Report to the Future Melbourne Committee**Agenda item 6.1****Planning Permit Application: TP-2022-23
204-208 Albert Street, East Melbourne****24 October 2023****Presenter:** Marjorie Kennedy, Acting Director Planning and Building**Purpose and background**

Application number:	TP-2022-23
Applicant:	Whitehaven Property Development Pty Ltd
Owner:	Whitehaven Property Development Pty Ltd
Architect:	Jackson Clements Burrows Architects
Address:	204-208 Albert Street, EAST MELBOURNE VIC 3002
Proposal:	Partial demolition of the existing building, and the development of a multi-storey commercial building and associated works, and a reduction of the car parking requirement
Estimated cost of development:	\$15,000,000
Date received:	21 January 2022
Date amended:	15 September 2023
Responsible officer:	Rochelle Fleming, Senior Urban Planner

6 LEVELS, 1500mm EAST SETBACK

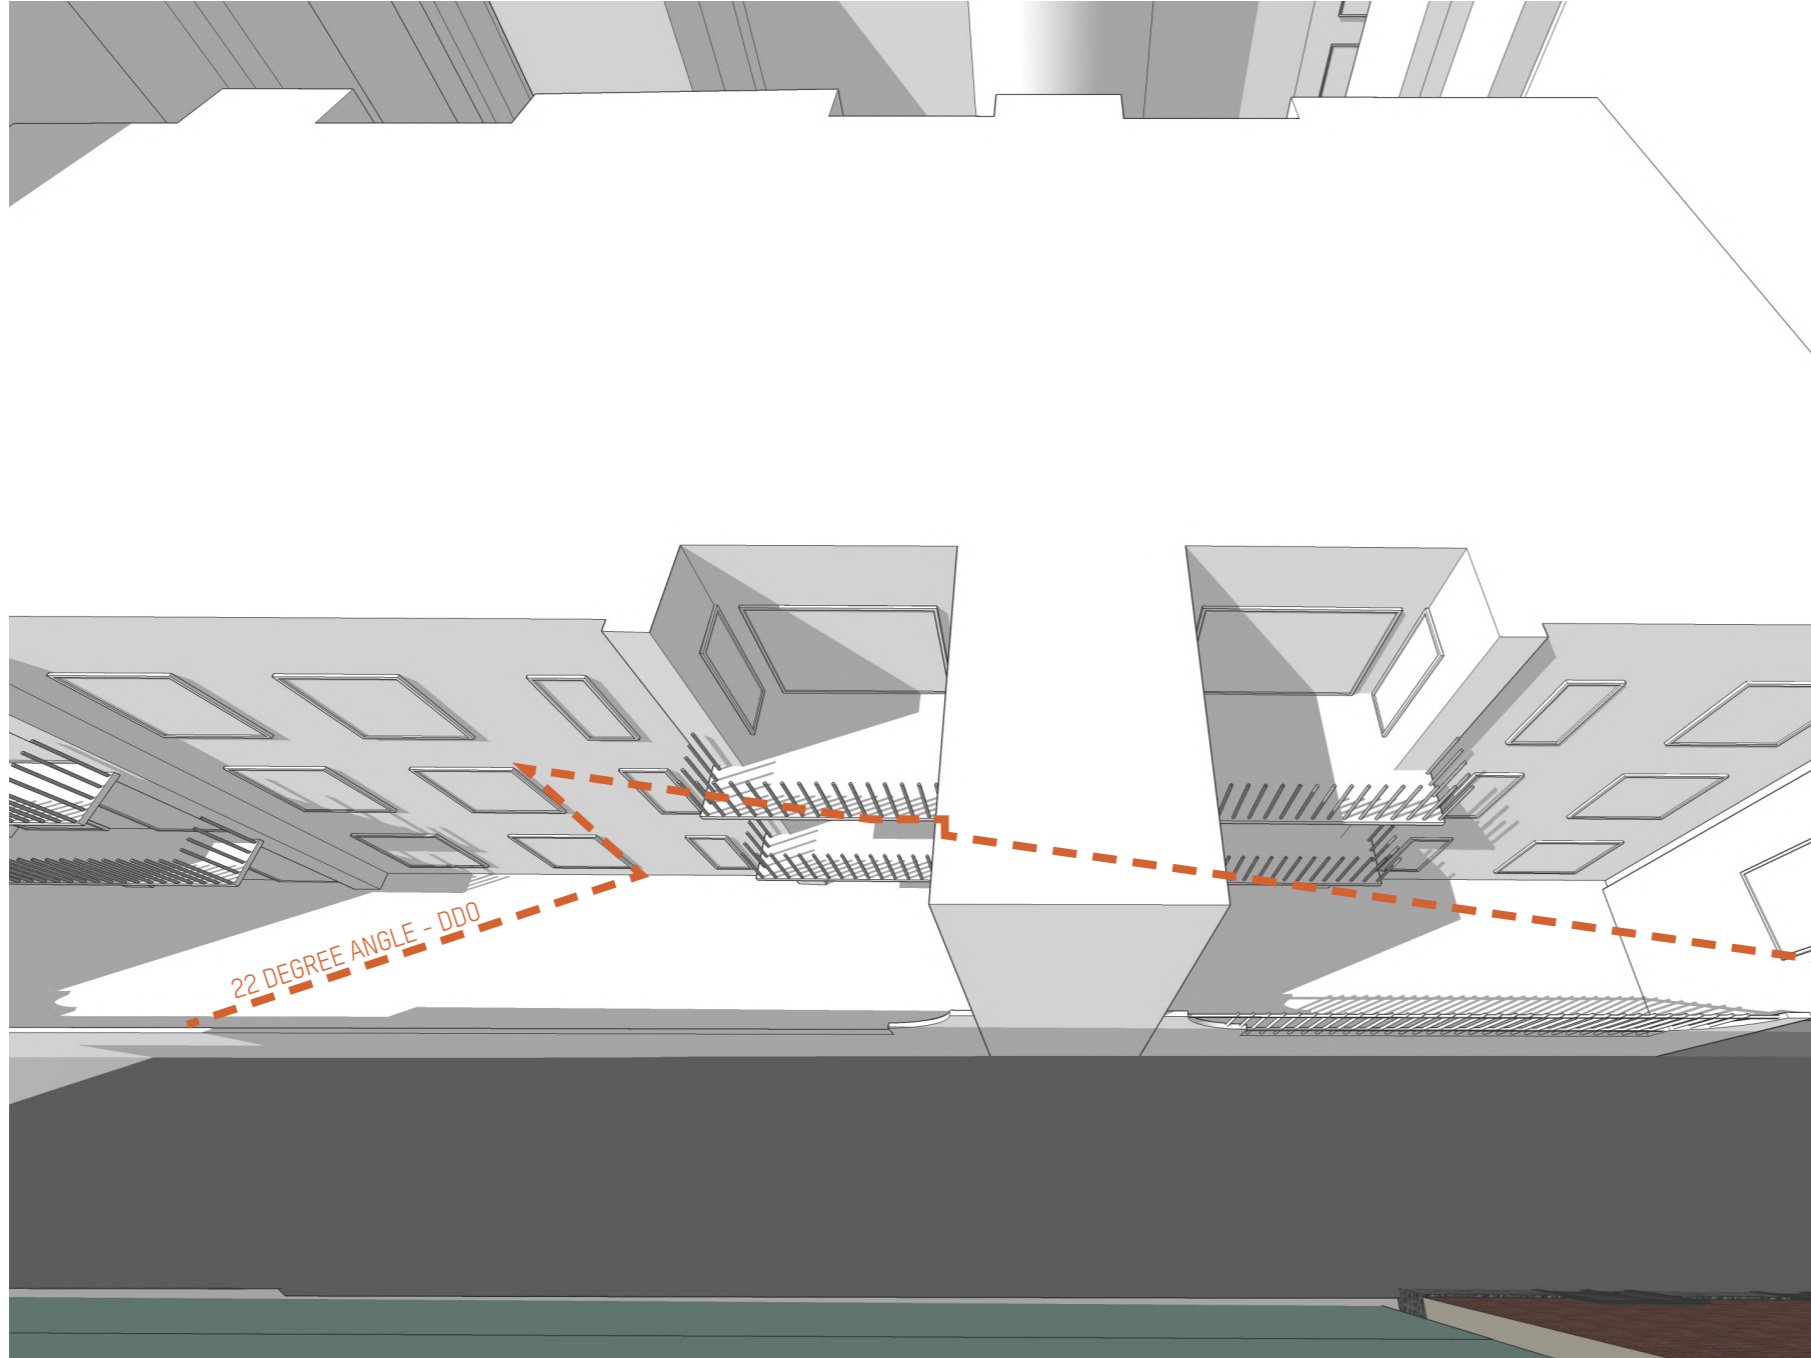
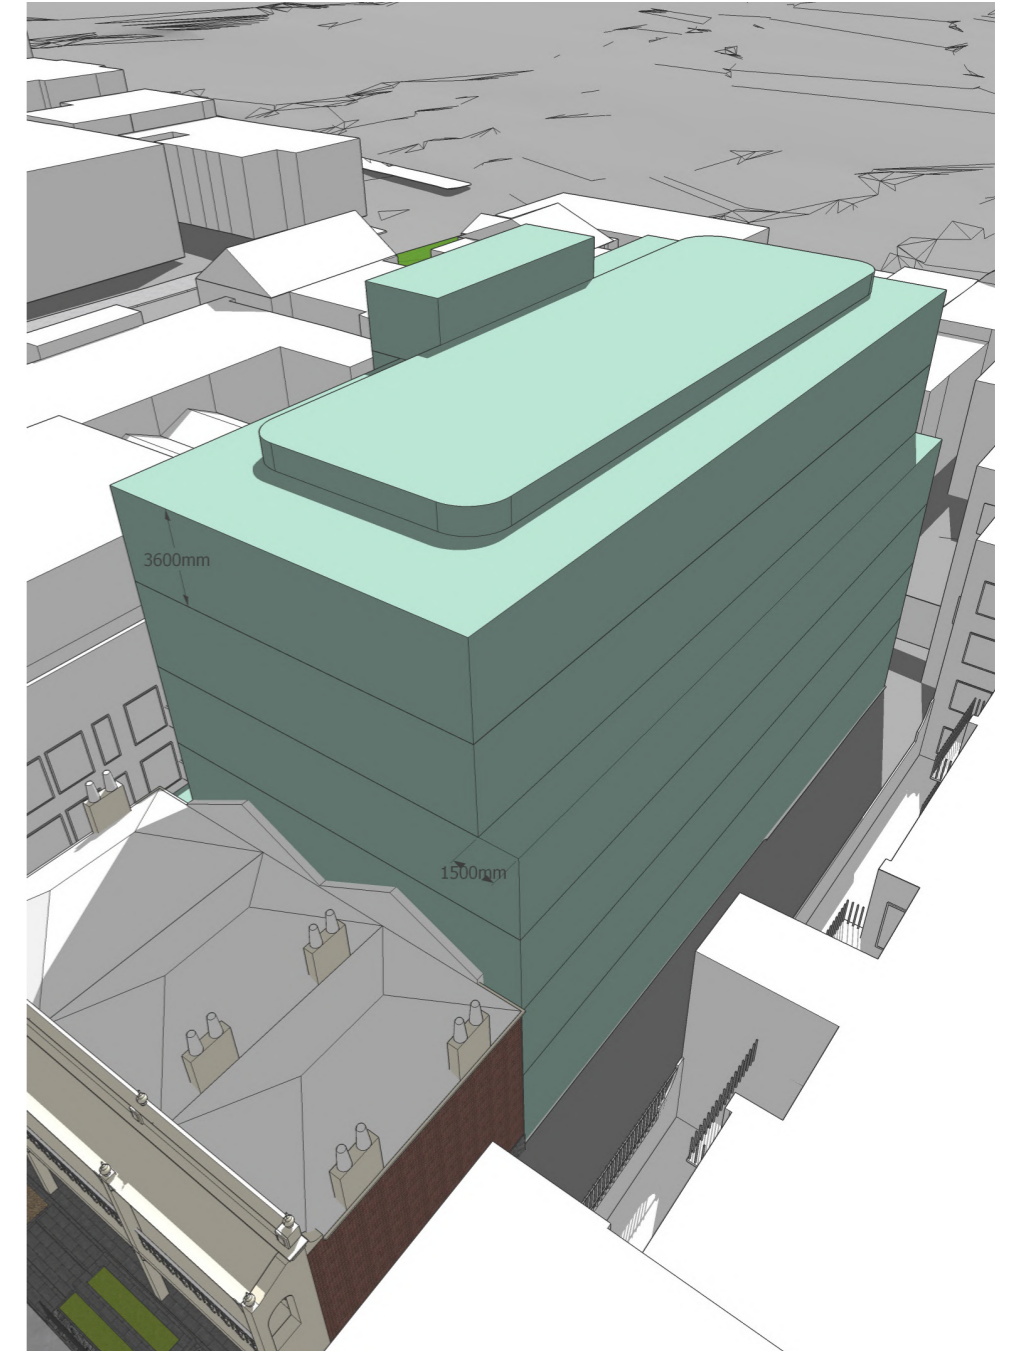
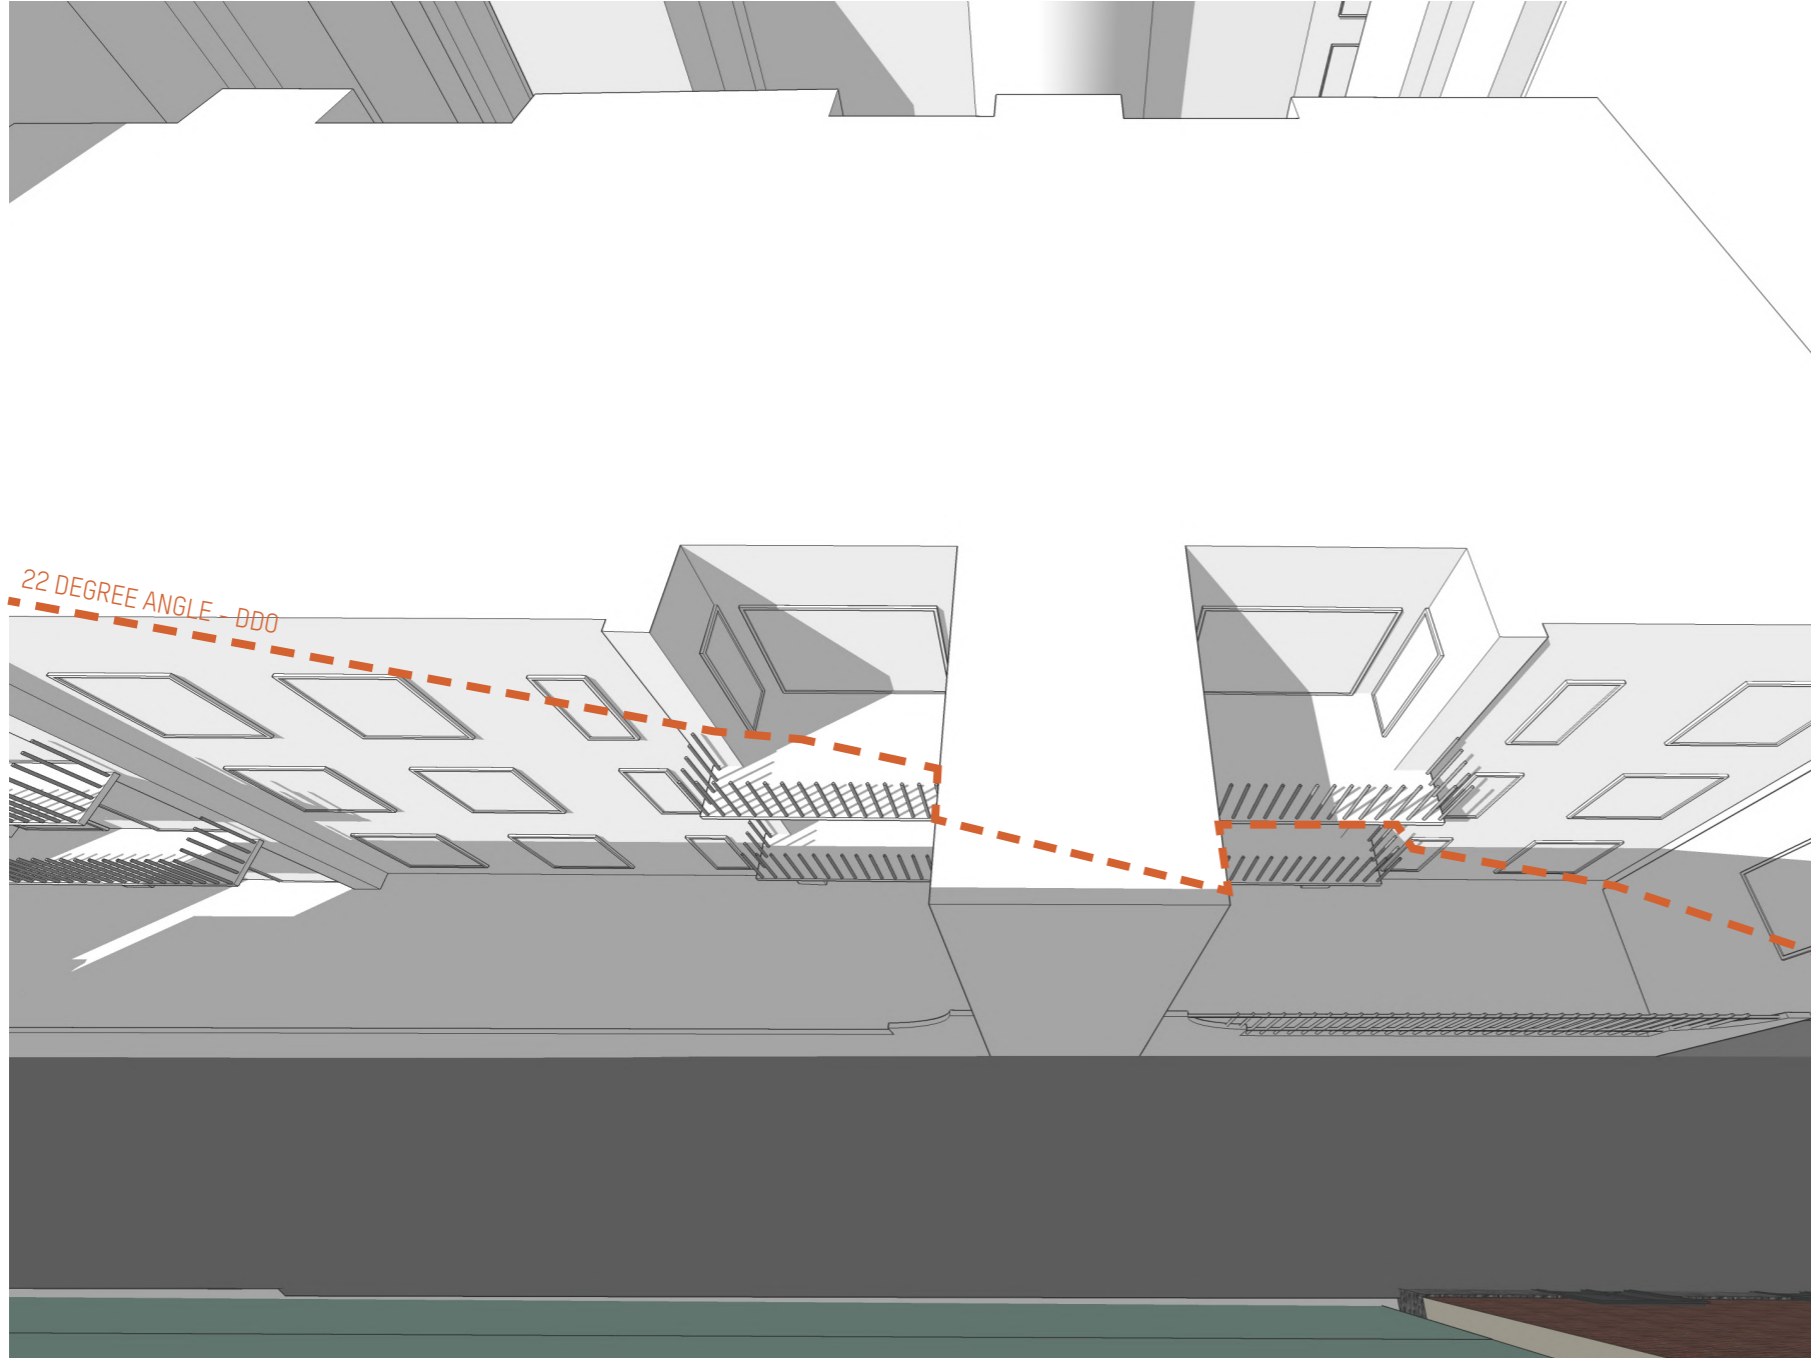
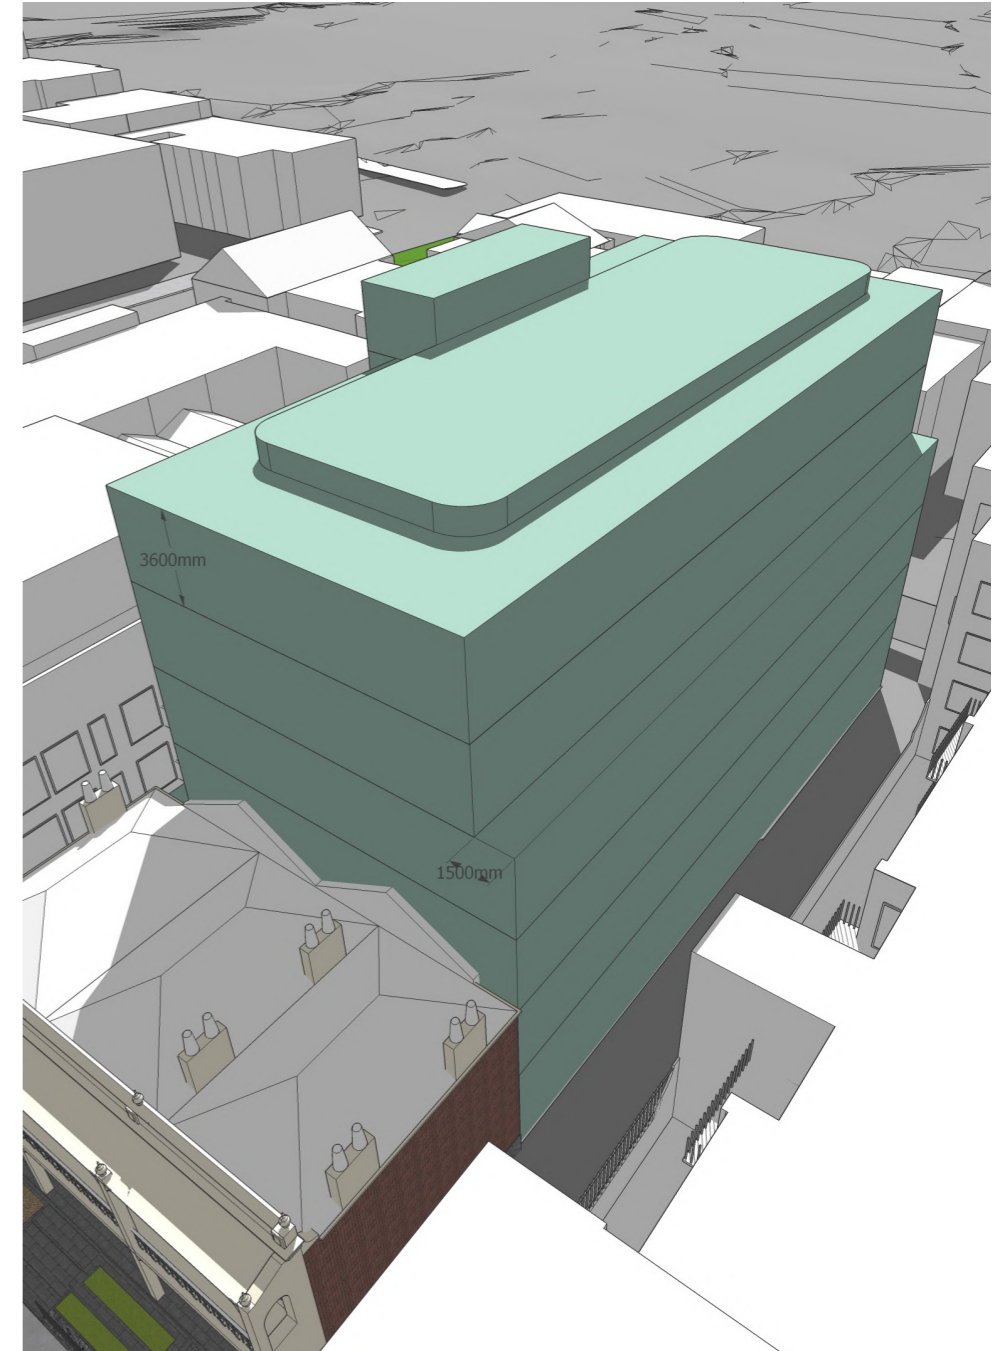
As part of the Section 57A Amended Application the setback to the east of the Site has been reduced from 3.4 metres to 1.5 metres at the upper two levels. This will have a revised visual bulk and outlook impact on the apartments at 200 Albert Street, which is discussed at Section 12.3.1 below.
